## ACTION OF THE CITY OF DULUTH PLANNING COMMISSION

PL 12-013 (R-P Plan). Related to PL 12-012  
(Rezoning to R-P)

**First Amendment to the Regulating Plan (Approved May 24<sup>th</sup>, 2012)**

## Second Amendment to the Regulating Plan (Approved May 24<sup>th</sup>, 2012)

# Exhibit A

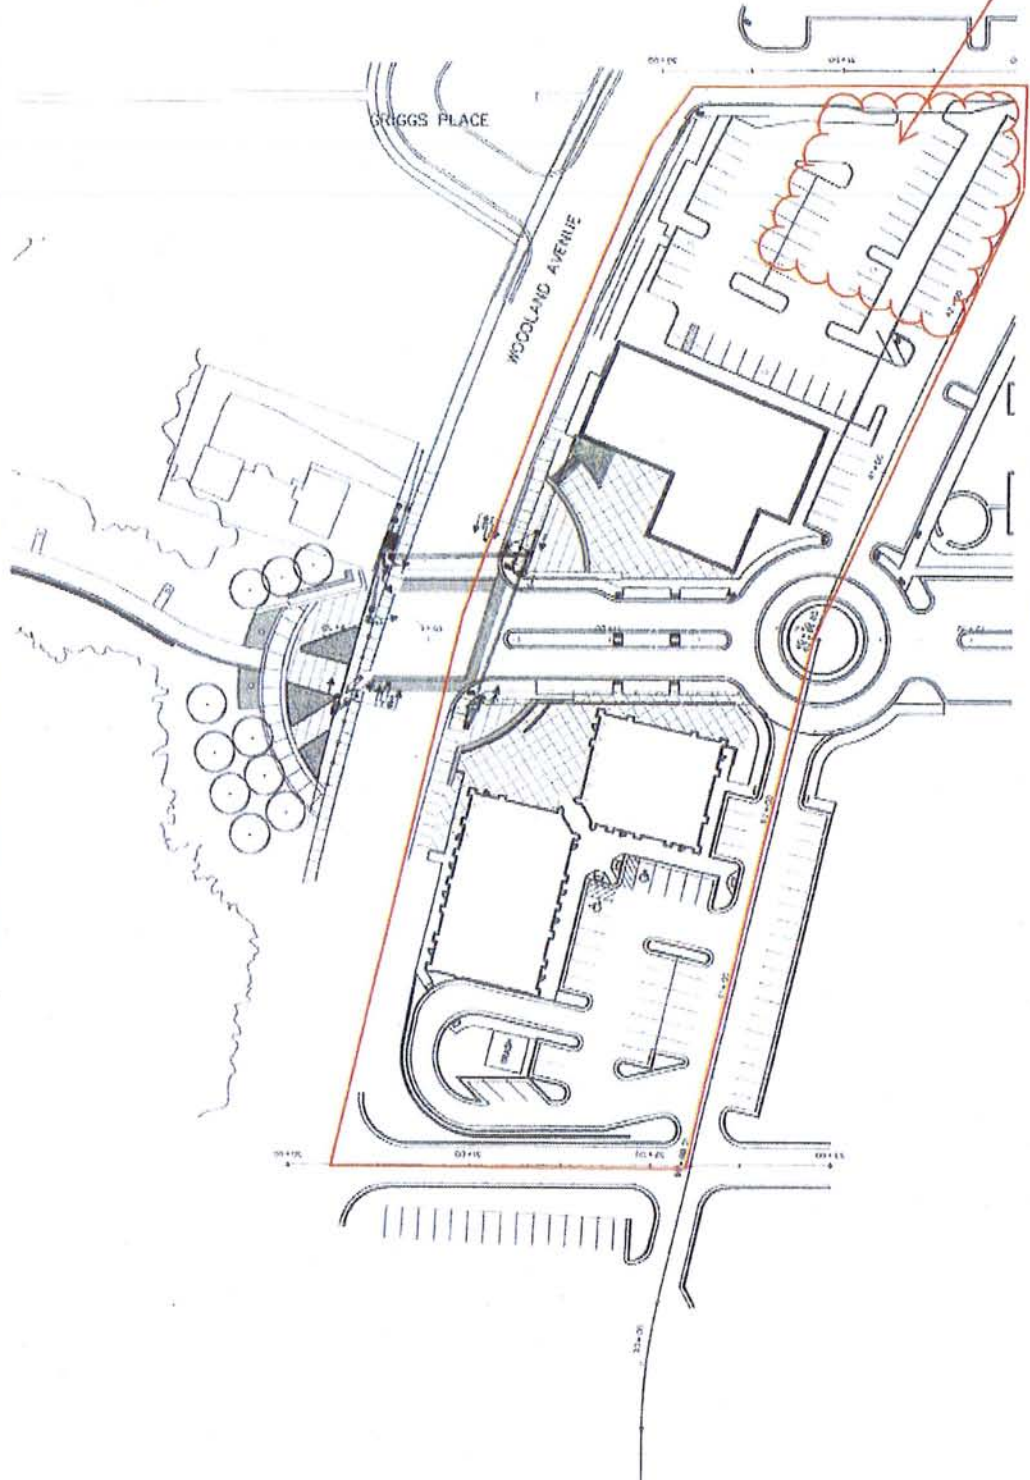
Following leasing discussions with third party retailers and changing market conditions, the BlueStone Site Plan has been modified and updated. These changes include the temporary removal of the northernmost retail building located along Woodland Avenue from the Site Plan and its designation as "Future Retail", and the joining of the two retail buildings located at the southeast intersection of Summit Street and Woodland Avenue, all as generally depicted and highlighted in red on the attached Exhibit A.

With respect to Tracts E, F, G, K and L, the approved Site Plan contained within the Applicants' Regulating Plan is hereby amended to include the attached Exhibit A.

# ALTA/ACSM LAND TITLE SURVEY EXHIBIT A - PHASE 1R SITE PLAN

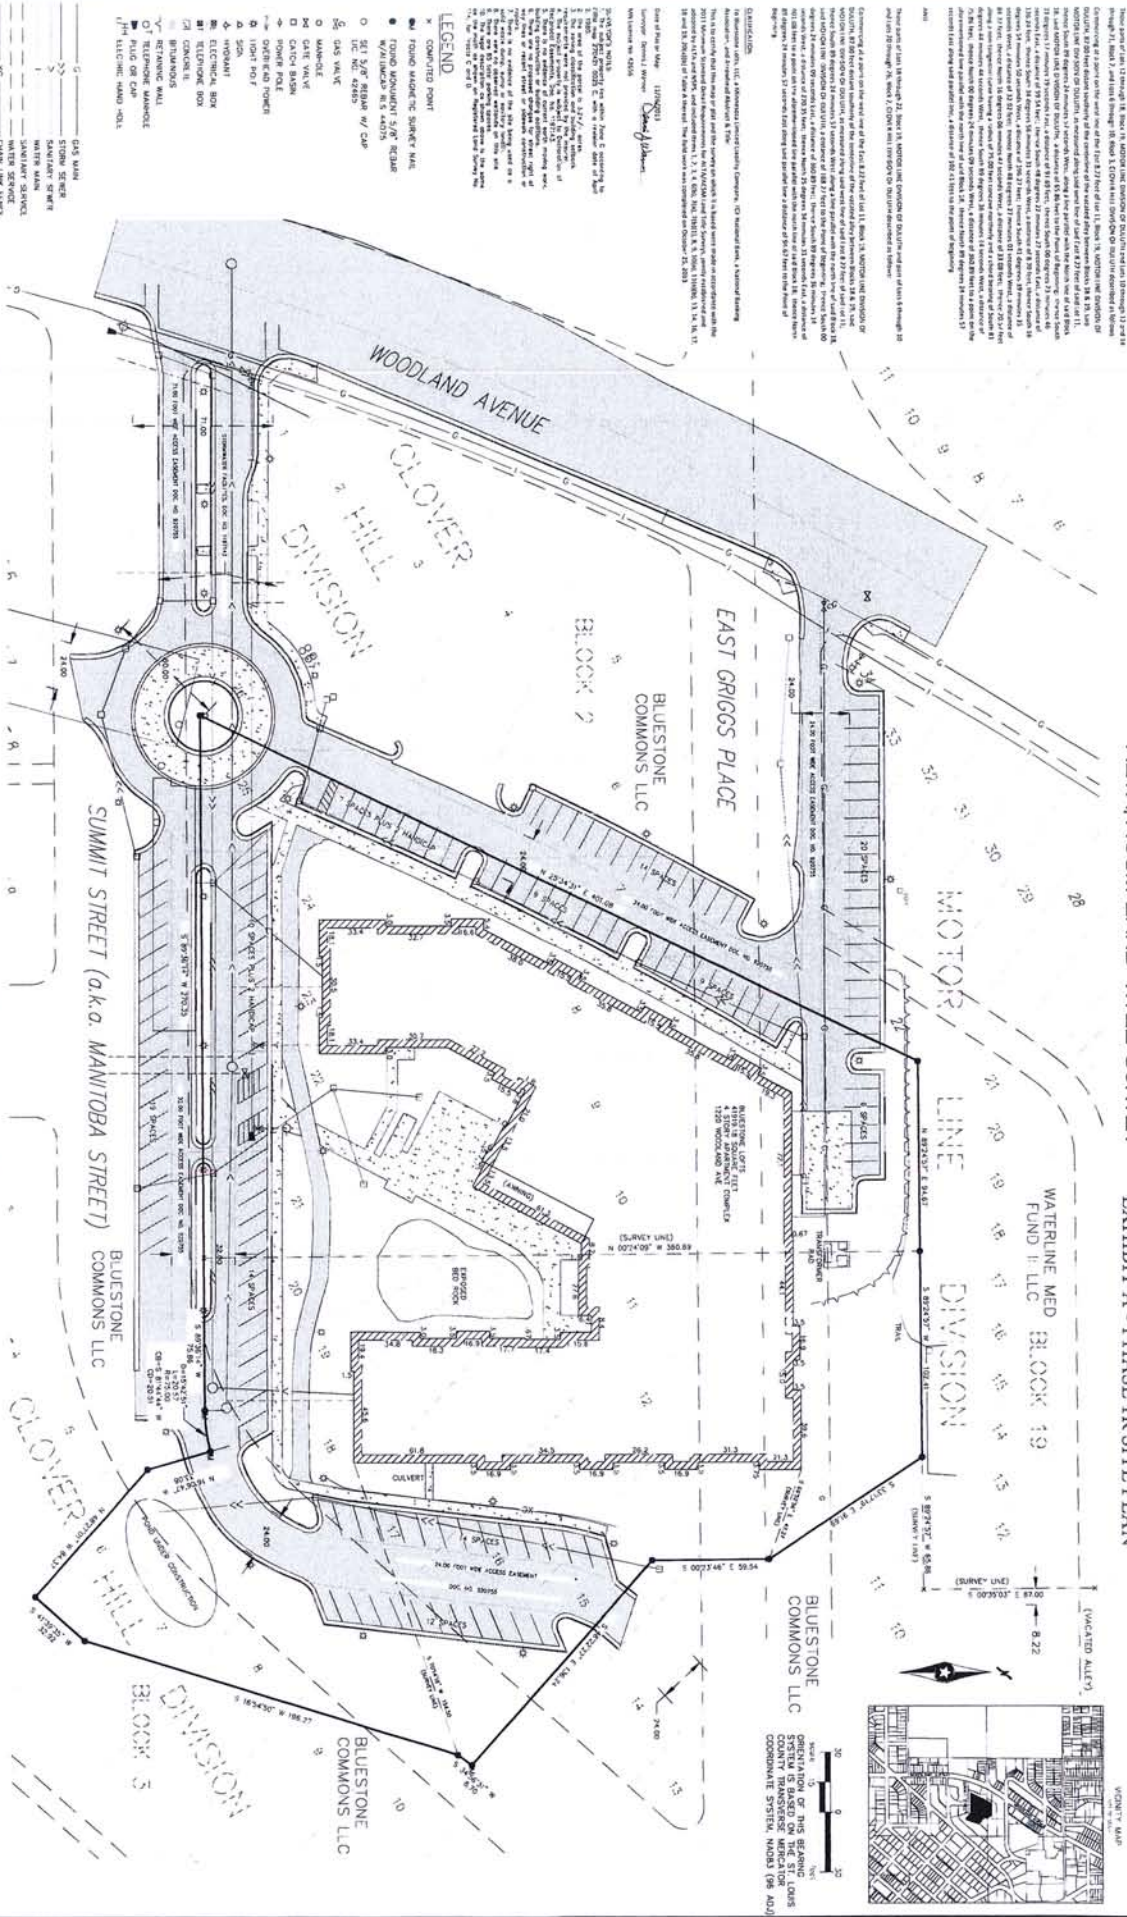
- Exhibit A – Phase 1R (BlueStone Lofts) final ALTA survey and site plan
- Exhibit B – Phases 1C and 2C (Shops at BlueStone II/Tavern on the Hill) permitted site plan
- Exhibit C – Phases 3C and 4C (Shops at BlueStone) final site plan

EXHIBIT D - LIGHTING PLANS

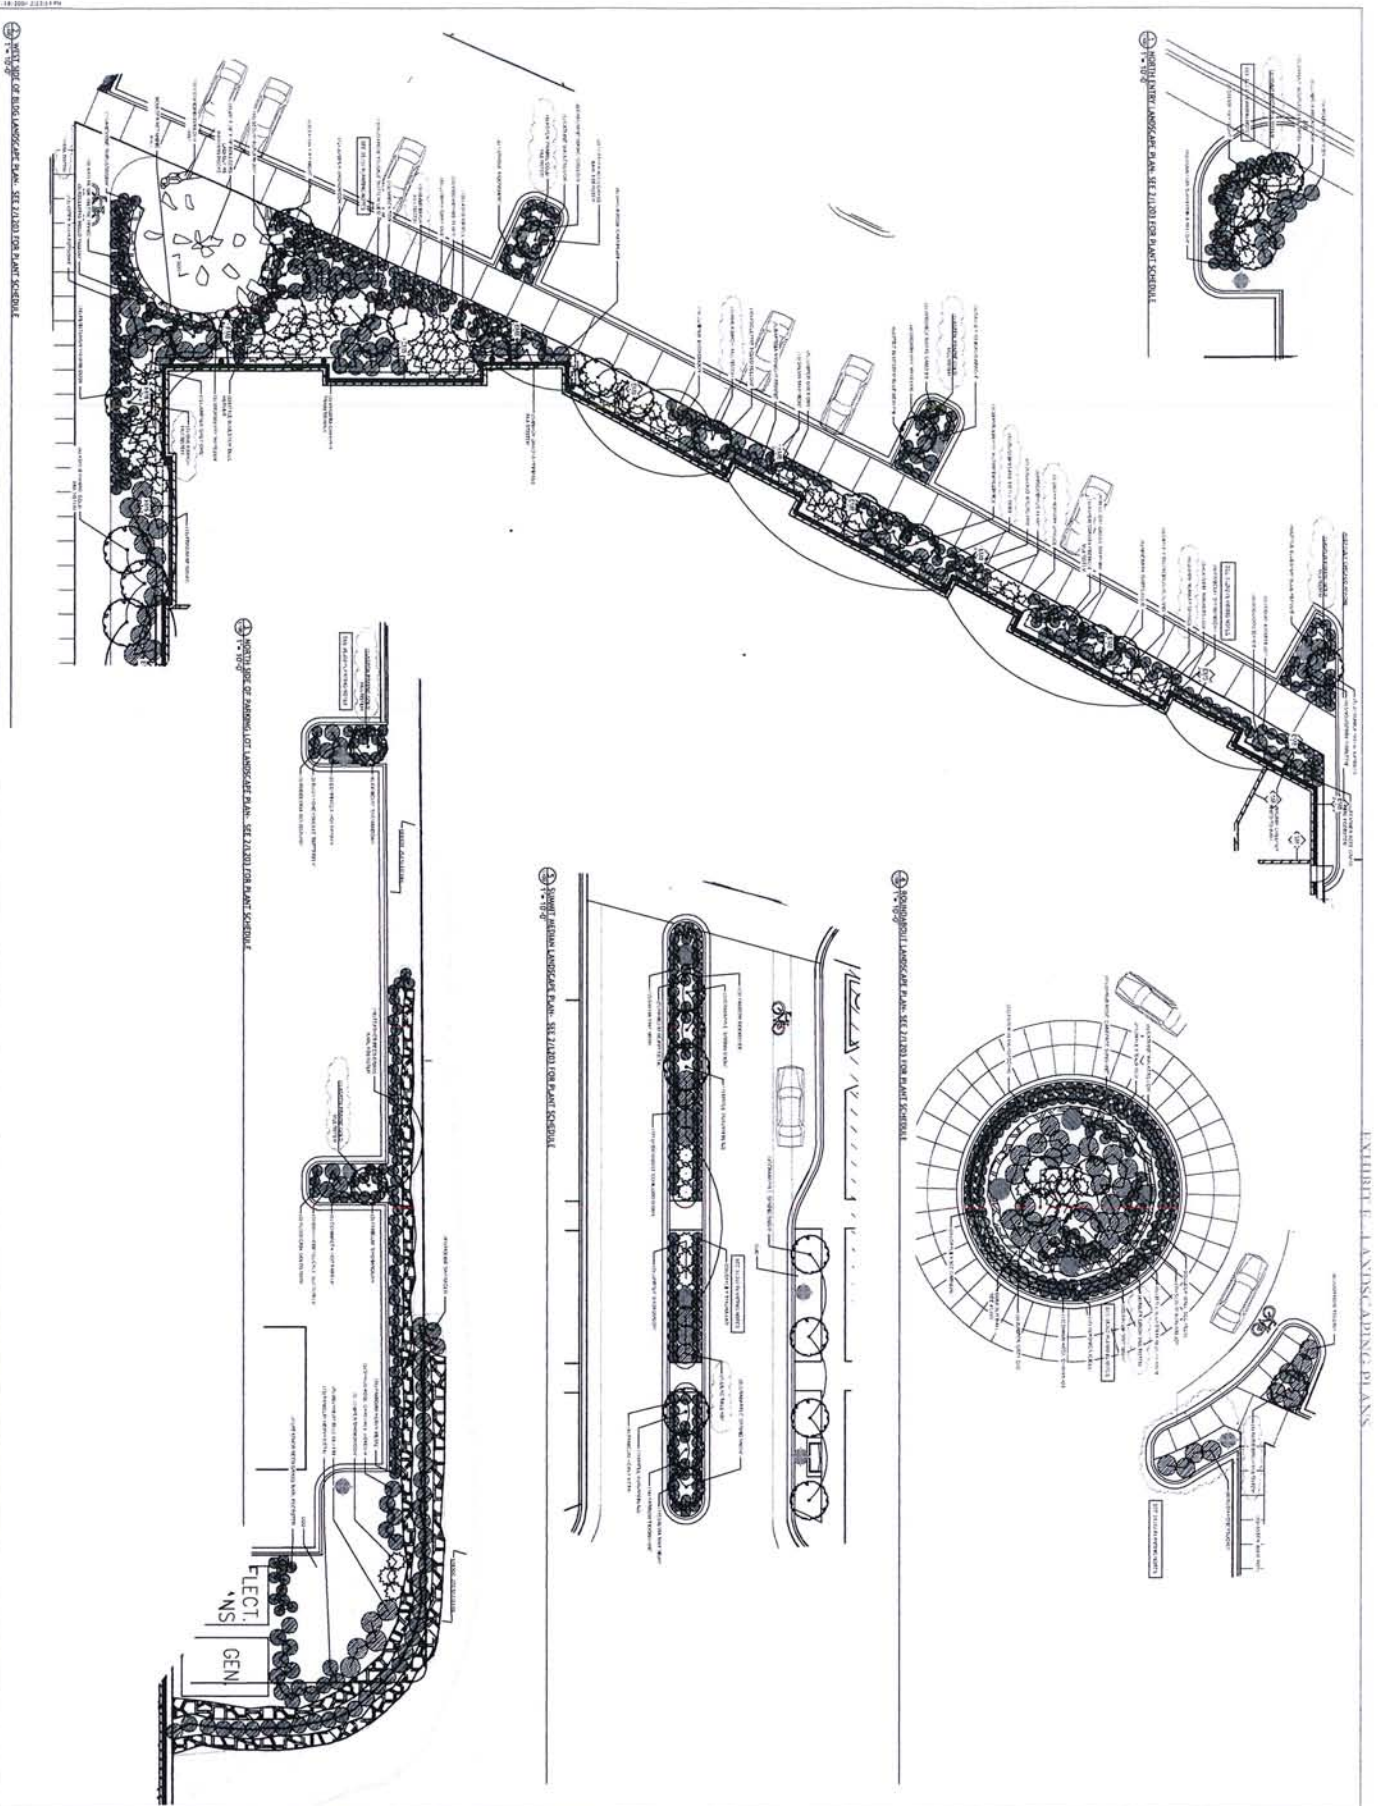
- Exhibit D – Lighting plans and drawings
- Exhibit E – Landscaping plans

# Exhibit D

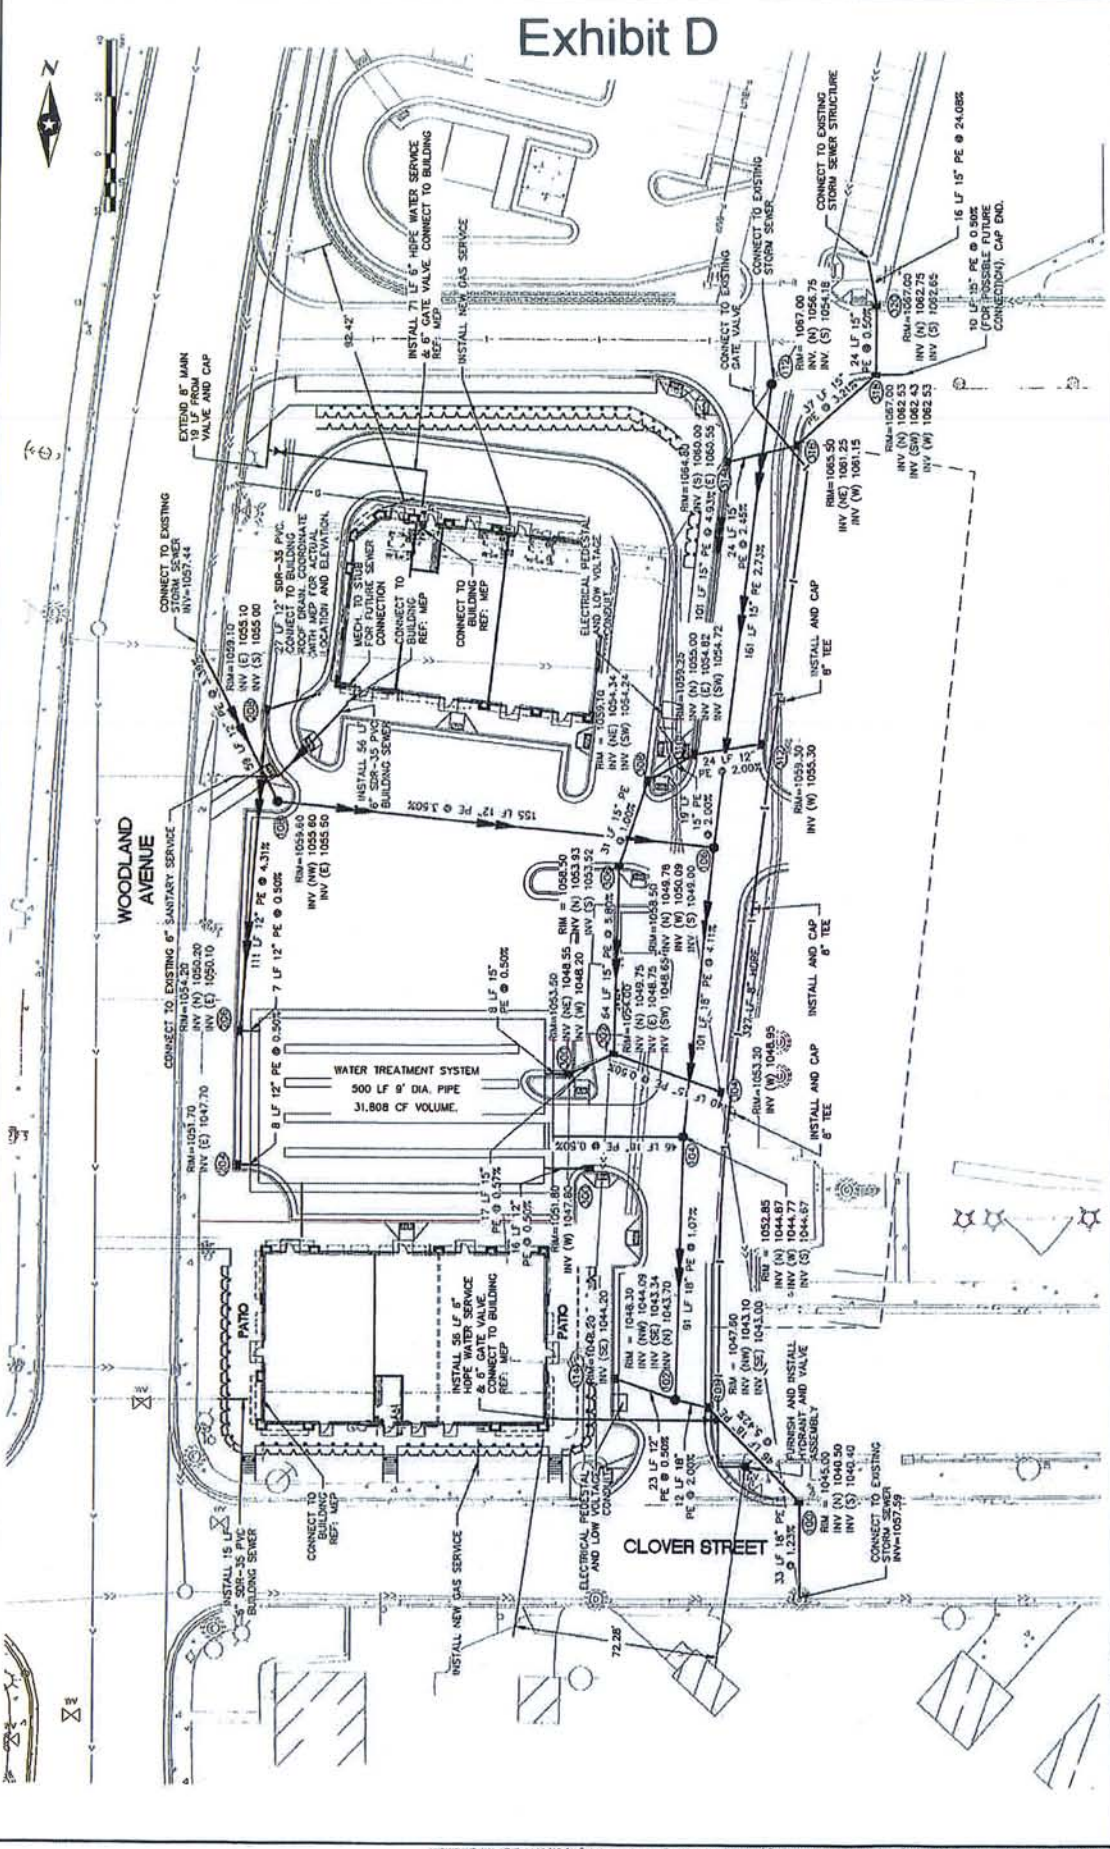
Exhibit D – Update underground storm water plan for Phase 5C (Shops at BlueStone III)
